P 534028

Septic Repair 4340655 ON-SITE SEWAGE DISPOSAL SYSTEM HOWARD COUNTY HEALTH DEPARTMENT BUREAU OF ENVIRONMENTAL HEALTH

ADDRESS: 14022 Celbridge Drive PROPERTY OWNER: Mary Jo Kishter

TRENCHES:	
LOCATION:	
PURPOSE:	Replace pump in pump chamber and add an alarm to the system. Line between the septic tank and pump chamber needs to be repaired.

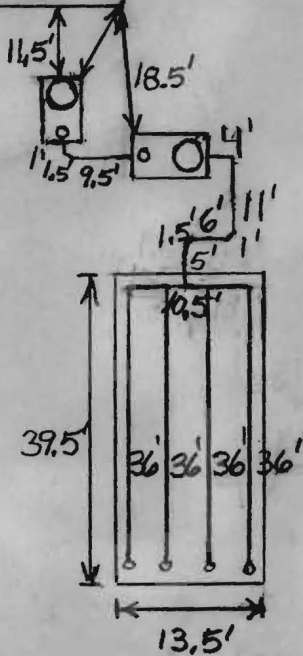
4/1/2011 Pump tank and bed locations laid out and discussed installation. (BB)

7/6/2011 Pump chamber set and connected to existing tank. (BB)

7/7/2011 Contractor working on bed. (BB)

7/8/2011 Bed finished except for laterals, etc. (BB)

7/11/2011 Alarm working. Pump is delivering 3.5' of head on laterals with ball valve fully open. A Victory 93511 1/2 H.P. pump was used. This pump has a little less power than a 1/2 H.P. Goulds pump or equivalent. O.K. to backfill. (BB)

14022 Celbridge Drive - Mary Jo Kishter

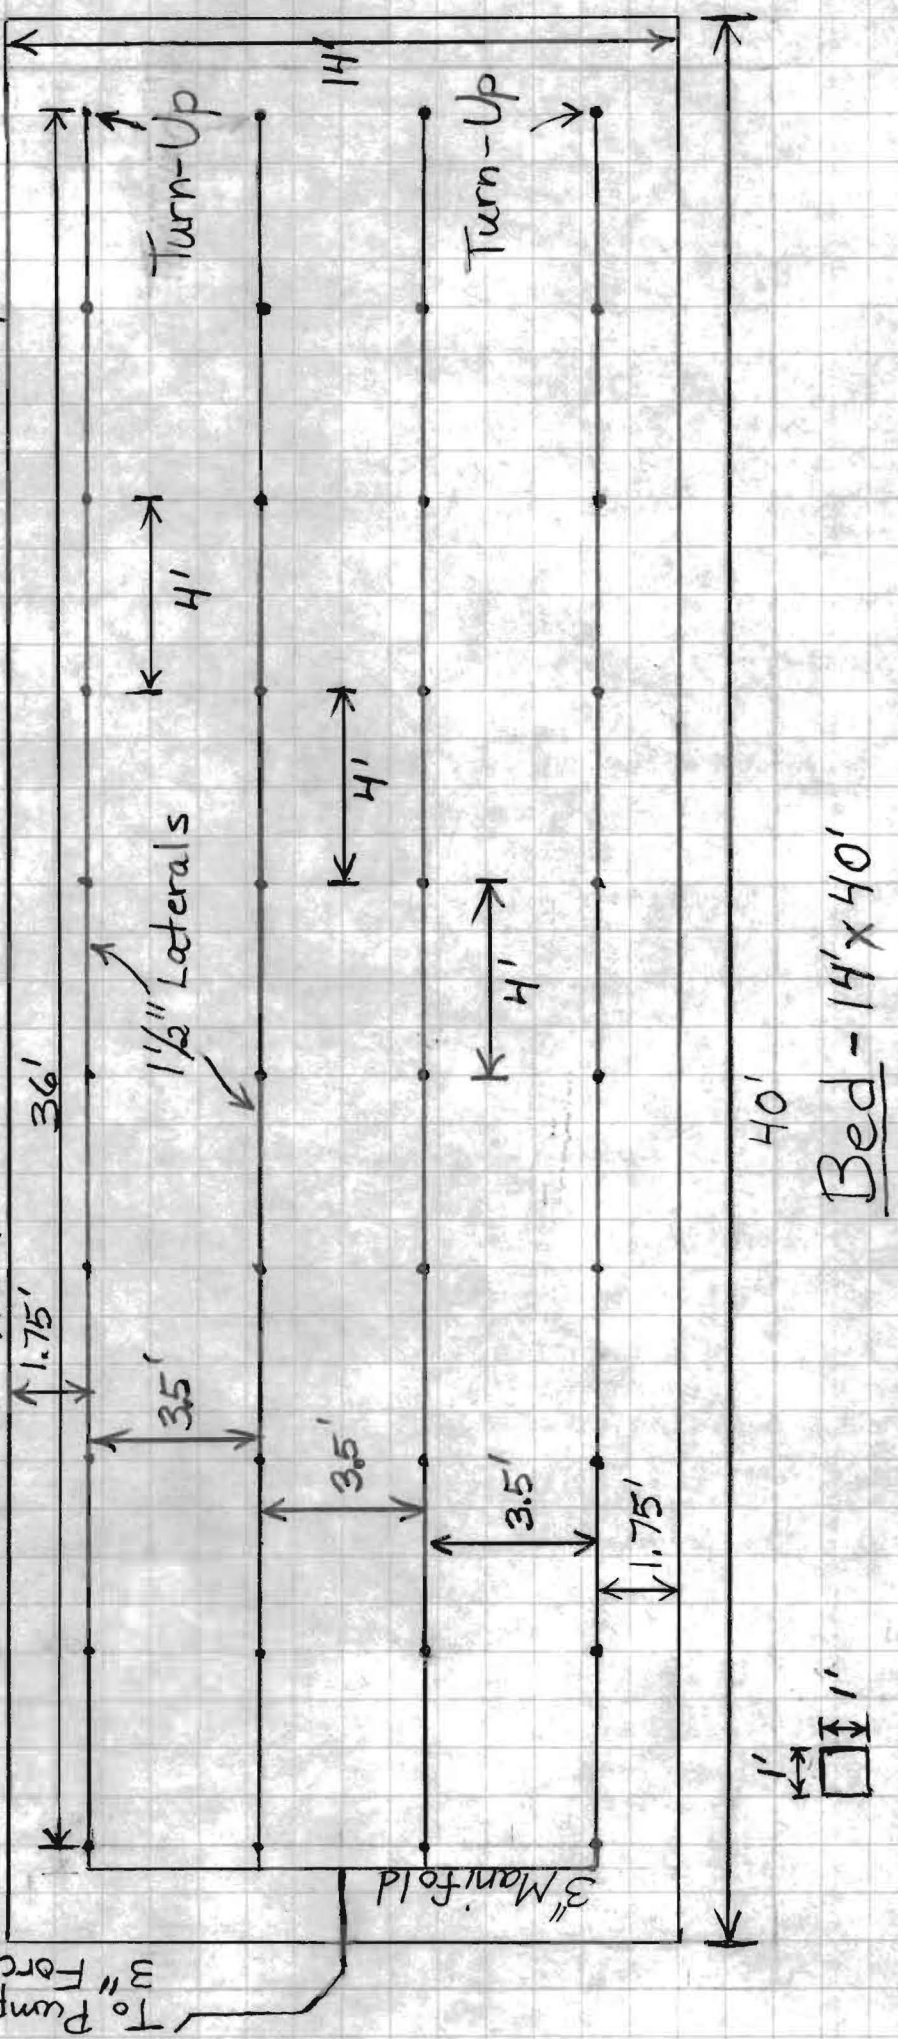
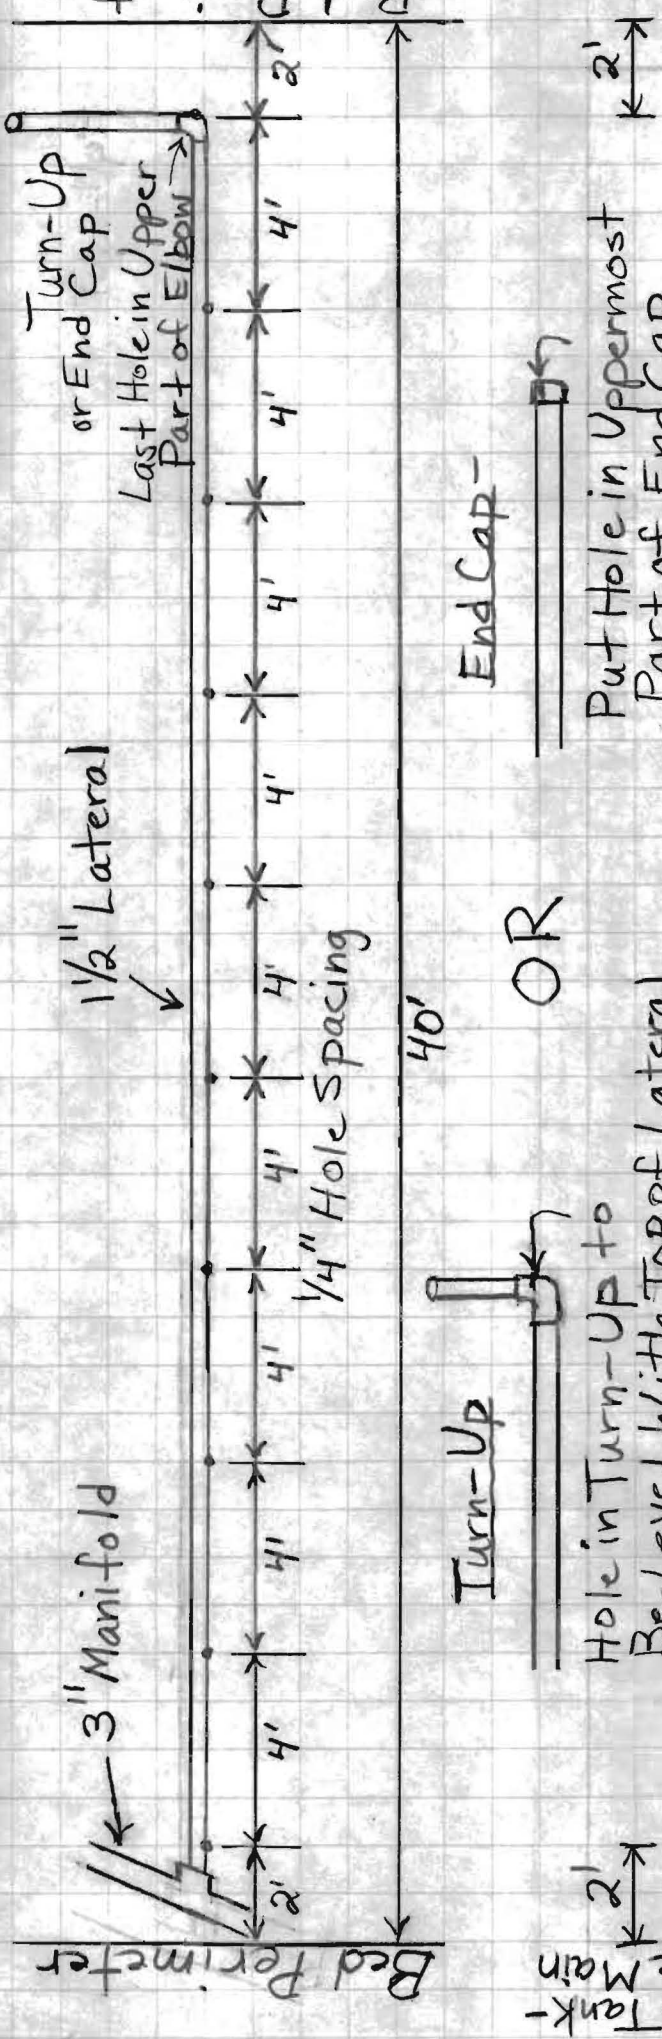
- Make Bed Depth 6.5' at Lowest Elevation
- Keep Bottom of Bed Level
- Bed Depth at Highest Elevation Will Be Approximately 8' Deep
- Depth of Gravel 2' + Enough to Cover Laterals and Manifold
- Inlet 4.5' to Around 6', Bottom 6.5' to Around 8'
- Cover Bed With Geotextile Fabric

* Existing Bed Will Only Be 5'-6' From New Bed
Existing Bed May Have to Be Pumped Down to Prevent Sidewall Collapse While Digging New Bed, Existing Bed is 22' x 24' with ~2' of Gravel and is 4.5'-5.5' Deep, Supposedly

- Pump Chamber - 1500 Gallon Two Compartment With Baffles in Center and No Slot
- Tank Outlet to Be Used as Inlet, With 1000 Gallon Compartment For the Pump
- Manifold to Be 3" PVC
- Four Laterals to Be 1.5" PVC
- Laterals to Be 36.5' in Length With Turn-Ups on the Two Outer Laterals, End Caps On Other Two
- Turn-Ups to Be Cut Down to Grade After Testing

- ②
- Bed to Be Tested Before Laterals are Covered
 - Holes in Laterals to Be $\frac{1}{4}$ " in Diameter
 - Hole Spacing in Laterals to Be 4' Apart and First and Last Holes to Be 2' From Bed Sidewall
 - Laterals to Be 3.5' Apart With Outside Laterals 1.75' From Bed Sidewall
 - Measure Hole Spacing From Turn-Up or End Cap
 - 10 Holes Per Lateral

- Manhole Riser to Be Installed On Existing Tank and Pump Tank
 - Junction Box to Be Mounted on Wood Post Near Pump Tank
 - Alarm to Be Installed Inside the House On Different Breaker Than Pump
 - Pump Tank to Have 6" Cleanout on Front
 - Pump to Be Placed on Block in Pump Tank And Operated By a Float Tree

- Suggested Pump: Goulds $\frac{1}{2}$ HP or Equivalent 115 V or Equivalent
 - This Pump Will Work per My Calculations, However Installer is Responsible for Confirming this, A Minimum of 3' of Head is Required at Turn-Ups
 - If For Some Reason a $\frac{1}{2}$ HP Pump Is Required Then A Ball Valve Will Probably Be Needed

- Two Fairly Large Trees In Tank/Bed Area, Stumps Will Have to Be Dug Up

- Proposed Bed Only 5'-6' From Existing Saturated Bed - Will Existing Bed Need to Be Pumped Down Before Installing New Bed? Approximately 2' of Gravel in Existing 22'x24' Bed

- Two Large Trees in Proposed Bed and Pump Tank Area

Root Balls Will Have to Be Removed - Will Removing Root Balls Have Any Effect on Proposed Bed or Pump Tank?

Both Trees Will Have to Be Removed Because Bed and Tank Installation Will Kill/Destroy Them
